RE: S/D 00-17 -- Final Plat of STRUTHERS CREEK ADDITION

RE: S/D 00-17 -- Final Plat of STRUTHERS CREEK ADDITION

**CASE NUMBER:** S/D 00-17 -- STRUTHERS CREEK ADDITION

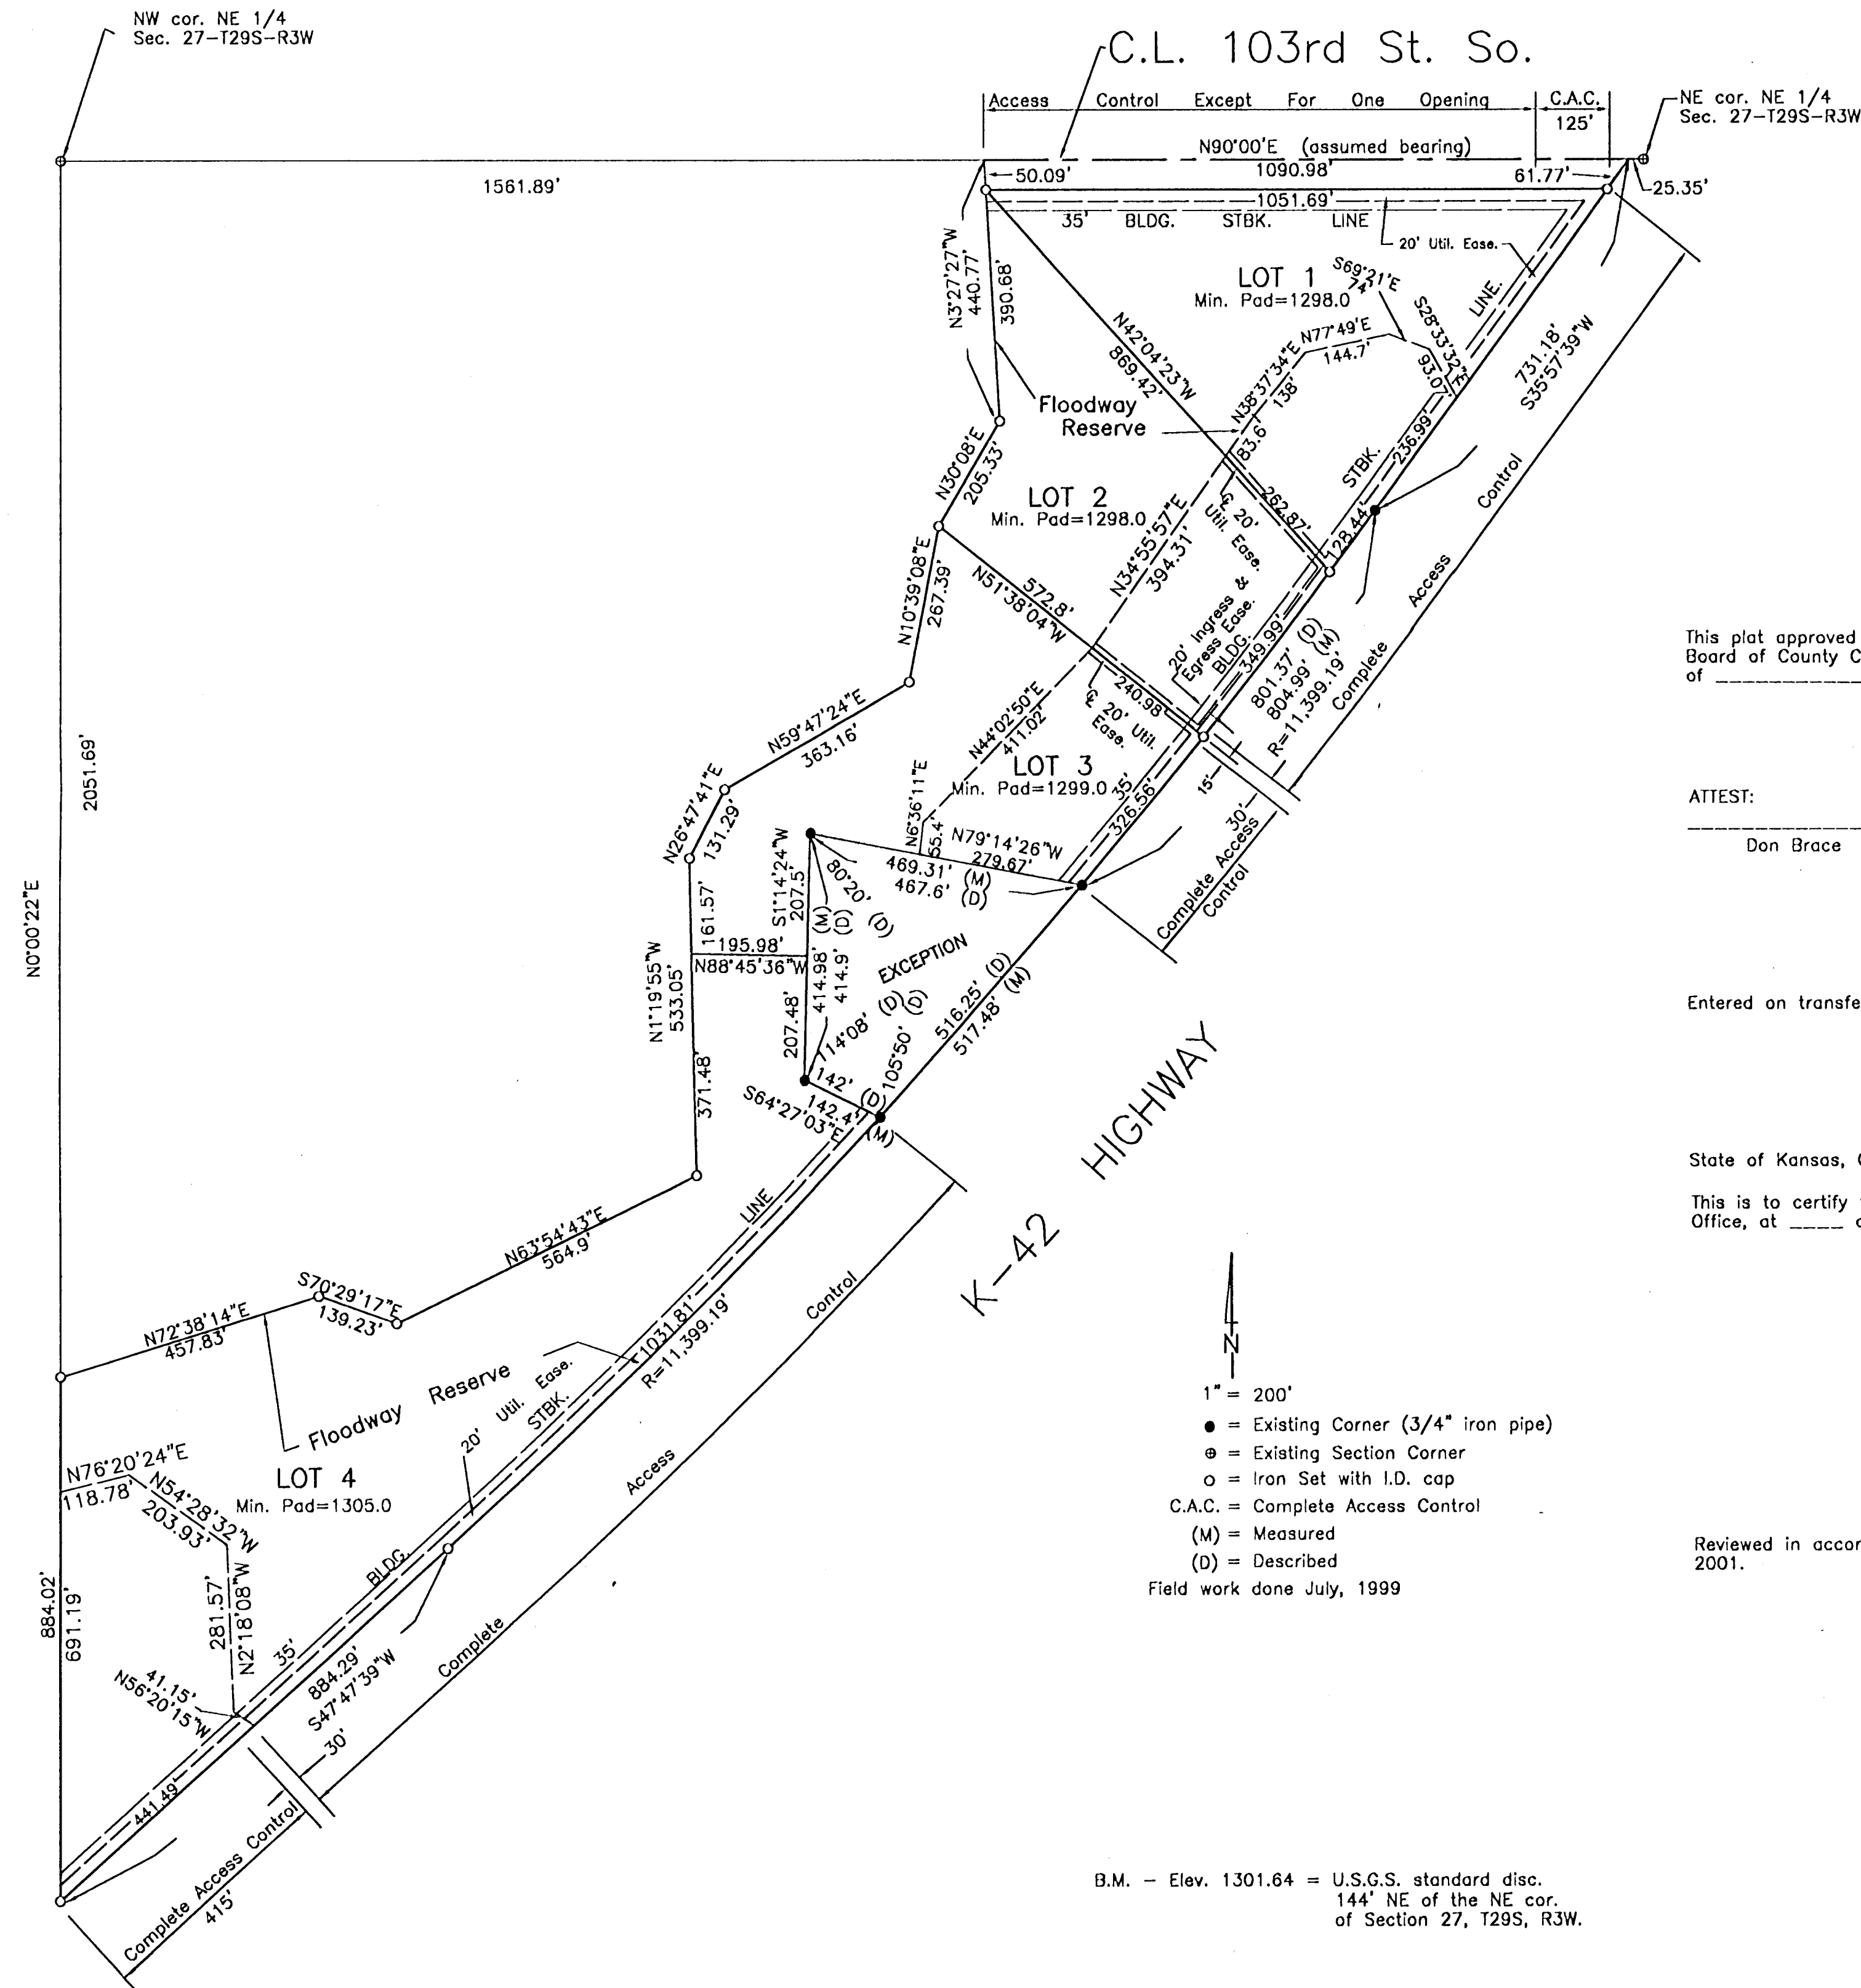
- A. Since neither municipal water nor sanitary sewer is available to serve this property, the applicant shall contact the Environmental Health Division of the **Health Department** to find out what tests may be necessary and what standards are to be met for approval of on-site sewerage facilities and water wells. A memorandum shall be obtained specifying approval. **A lot layout is required to be submitted for Lot 4. Additional soil testing is required.**

- C. **County Engineering** needs to comment on the status of the applicant's drainage plan. **The drainage plan is approved. Minimum pad elevations have been determined based on the HEC-2 Run - 1298 (Lot 1), 1298 (Lot 2), 1299 (Lot 3), and 1305 (Lot 4). A Letter of Map Amendment (LOMA) needs to be provided before release of the plat for recording.**

- D. The applicant has platted one opening along 103rd St. South, and two openings along K-42. **County Engineering** and **KDOT** need to comment on the access controls. **KDOT has approved two openings along K-42. County Engineering has required complete access control along the east 200 feet of the plat's frontage to 103<sup>rd</sup> St. South and one opening along the remaining frontage.**

- E. The joint access opening between Lots 2 and 3 needs to be established by separate instrument.

- F. County Surveying has advised that the plat boundary does not close.
- G. The Applicant is reminded that a platting binder is required with the final plat. Approval of this plat will be subject to submittal of this binder and any relevant conditions found by such a review.

- H. If platted, the building setback may be a minimum of 30 feet to conform with the RR District zoning standards.
- I. Thomas G. Winters shall be indicated as the Chairman of the County Commissioners.

- L. Marvin S. Krout shall be indicated as the Secretary of the Planning Commission.
- M. The plat's text shall delete the language referencing the dedication to the appropriate governing body of the access easement between Lots 2 and 3.

- N. The plat's text shall include language that a drainage plan has been developed for the plat and that all drainage easements, rights-of-way, or reserves shall remain at established grades or as modified with the approval of the applicable City or County Engineer, and unobstructed to allow for the conveyance of stormwater.
